**FINDINGS AND RECOMMENDATION
OFFICE OF PLANNING AND ZONING
ANNE ARUNDEL COUNTY, MARYLAND**

CASE NUMBER: 2025-0126-V

The applicant is requesting a variance to allow dwelling additions with less setbacks than required, with disturbance to slopes of 15% or greater and that does not comply with the designated location of a principal structure on a waterfront lot on property located at 353 South Drive in Severna Park.

VARIANCE PLAN

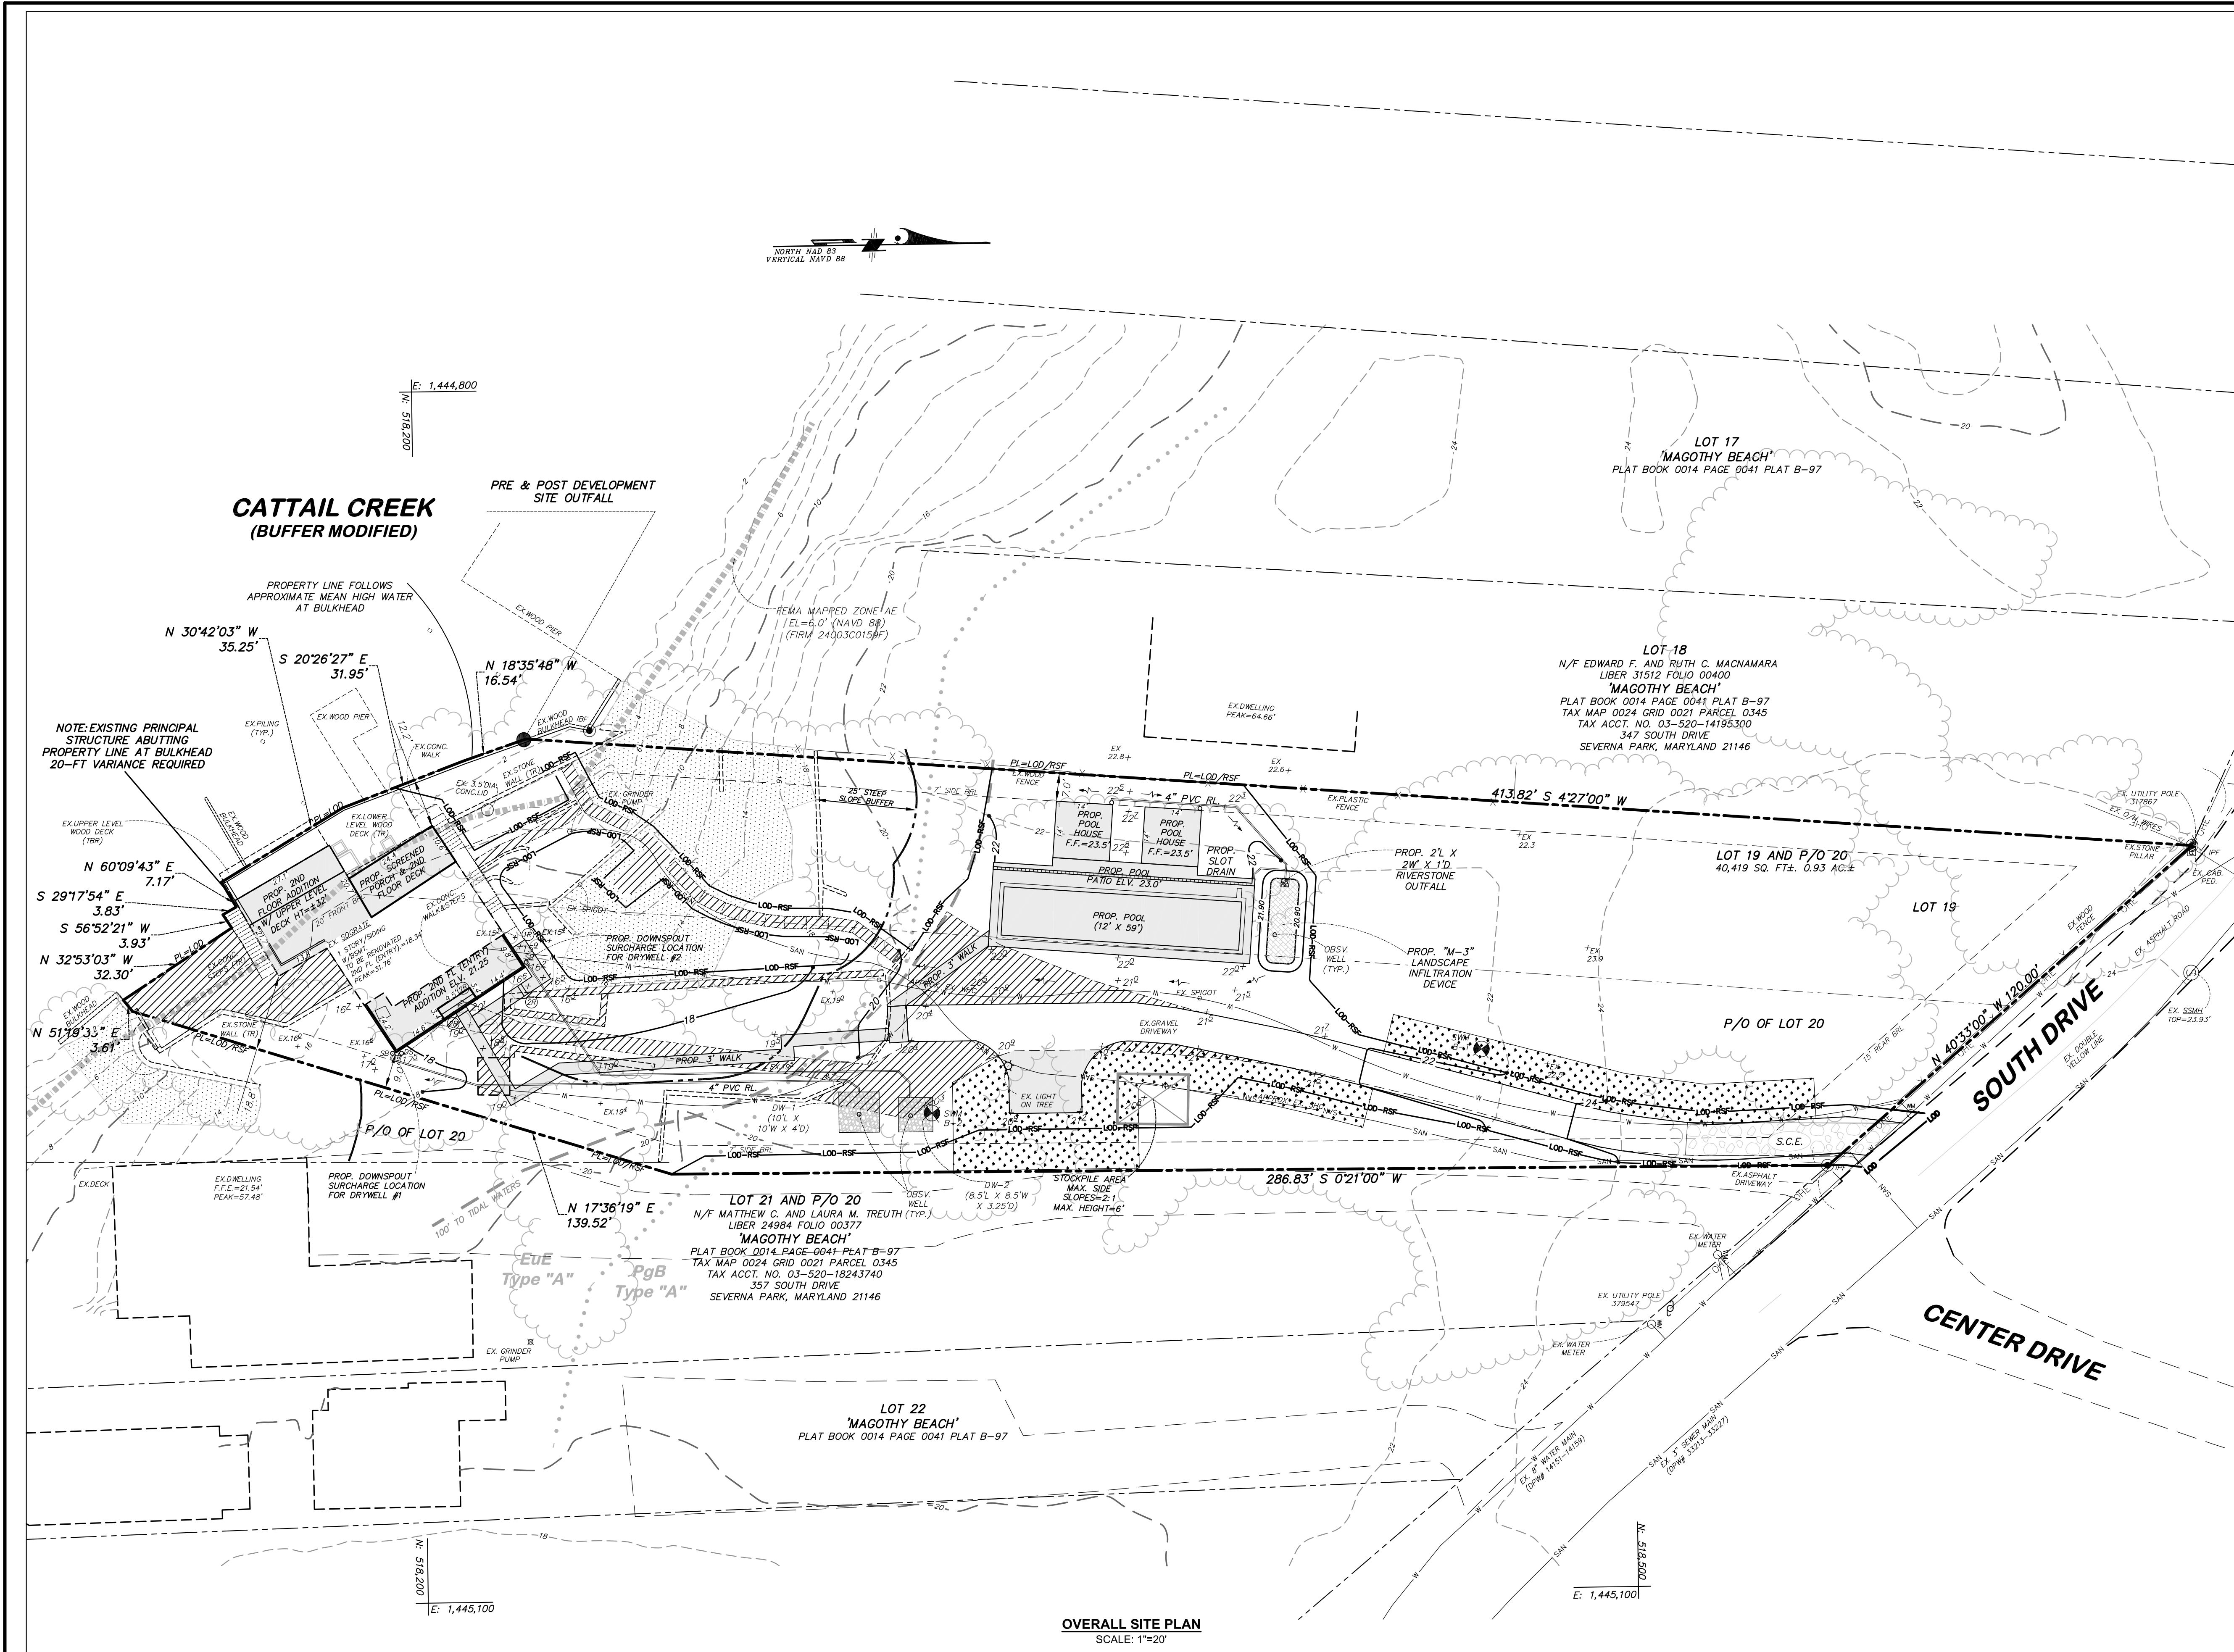
- 1. An existing utility easement is located from South Drive to the grinder pump per Geocortex (Deed Book 4356, Page 748). Show the easement on the plan sheets.

- 4. Drywells must be 10 feet from each other.
- 5. Label the size and material of the SHC and show as force main across the property.
- 6. Label the size of the water meter and the WHC.

- 7. The steep slope buffer and property line are too similar. Revise one of the line types.
- 8. Is there to be a sidewalk leading to the sauna? If so, show and label the width and material of the sidewalk.

- 9. Label the material of the proposed 3' walk.
- 10. Show the water meter in the correct spot as it is drawn on top of the water main. Label as existing or proposed.

- 11. Provide the classification, ownership, surface type, and width of South Drive.
- 12. If no work is to be done on the driveway at South Drive, remove the LOD from the right-of-way.
